November 2021
FL863A (Final)
INT FL863-01 (Interim)
NHTSA #20V-567
Transport Canada #2020-444

Subject: Freightliner Cascadia Brake Light Illumination

Models Affected: Specific model year 2017-2021 Freightliner Cascadia vehicles manufactured March 8, 2016, through January 3, 2020, and equipped with a certain brake light pressure switch.

Fig. 1, Possible 3-Pin Brake Light Pressure Switch Locations

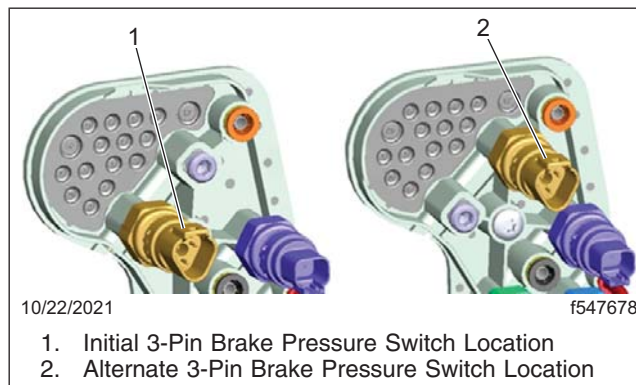
NOTE: Depending on the vehicle build date, the 3-pin brake light pressure switch may be in one of two locations on the pass-through switch manifold. See [Fig. 1](#).

4. Disconnect and remove the 3-pin brake light pressure switch.

Fig. 4, Jumper Harness Connected to Cab Harness

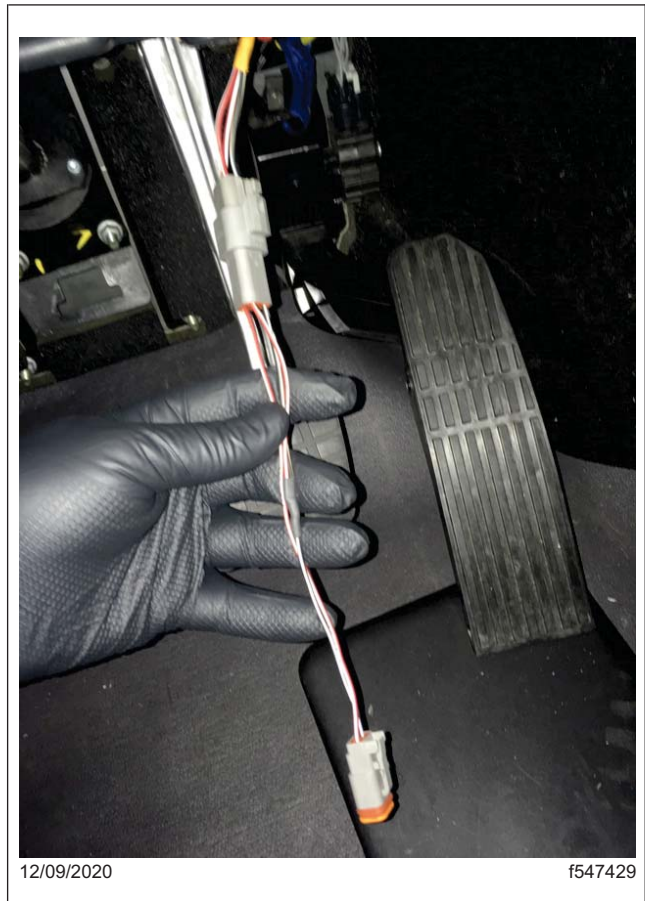
- 5.2 Install the jumper harness (see **Fig. 3**) onto the dash connector (see **Fig. 4**) and then connect it to the new 2-pin brake light pressure switch. Continue to step 6.
